Access Compliance Report

Public Rights-of-Way

(Curb Ramps)

Intersection ID: 13277	Main Street: SPRUCE_ST	Cross Street: WILMORE_DR	Location: SW
ADA ID: FB5C4E4154B2	Ramp Type: PerpDiag	Initial Pass/Fail: Fail	Overall Compliance: No
Severity Score: 13.75			
Codes/Mitigation Info/Possible Solution		Field Measurements/Component Compliance

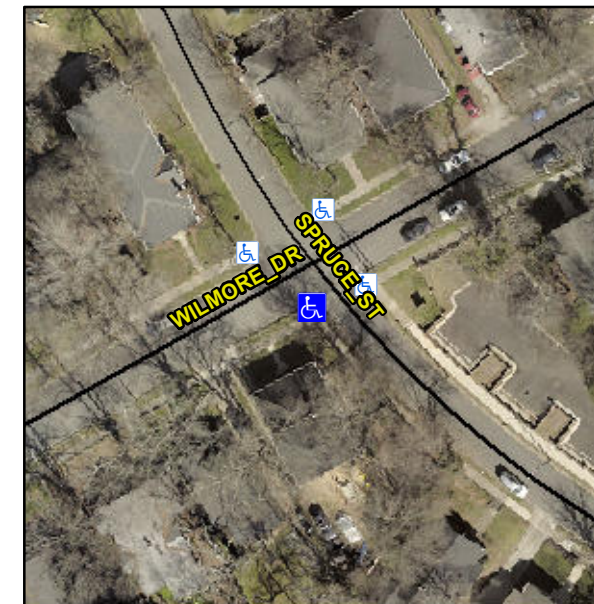
Not Found, R304.2.2, R304.5.3

Compliance	Description	Data	Compliance	Description	Data
N/A	Ramp Length (in)	60.0	No	Ramp Slope (%)	8.6
Yes	Ramp Width (in)	48.0	No	Ramp XSlope (%)	2.3
N/A	Flare Type LT	N/A	N/A	Flare Type RT	N/A
N/A	Flare Slope LT (%)	N/A	N/A	Flare Slope RT (%)	N/A
N/A	Flare Traversable LT?	N/A	N/A	Flare Traversable RT?	N/A
N/A	Landing Length (in)	N/A	N/A	DWS Provided?	N/A
N/A	Landing Width (in)	N/A	N/A	DWS Contrast?	N/A
N/A	Landing Slope (%)	N/A	N/A	DWS Length (in)	N/A
N/A	Landing X Slope (%)	N/A	N/A	DWS Full Width?	N/A
N/A	Landing Curb? (Y/N)	N/A	N/A	DWS Offset (in)	N/A
N/A	Shared Landing?	N/A			
N/A	Gutter Ponding?	N/A	N/A	Gutter Slope (%)	N/A
N/A	Gutter Lip Ht (in)	N/A	N/A	Gutter X Slope (%)	N/A
N/A	Painted X Walk1?	No	N/A	Painted X Walk2?	No
	X Walk 1 Direction	To NE		X Walk 2 Direction	To NW
N/A	X Walk 1 Width (in)	N/A	N/A	X Walk 2 Width (in)	N/A
	X Walk 1 Slope (%)	6.8		X Walk 2 Slope (%)	5.1
	X Walk 1 X Slope (%)	0.3		X Walk 2 X Slope (%)	5.4

Remove & Replace Curb Ramp With Two New Directional Ramps or Equivalent.
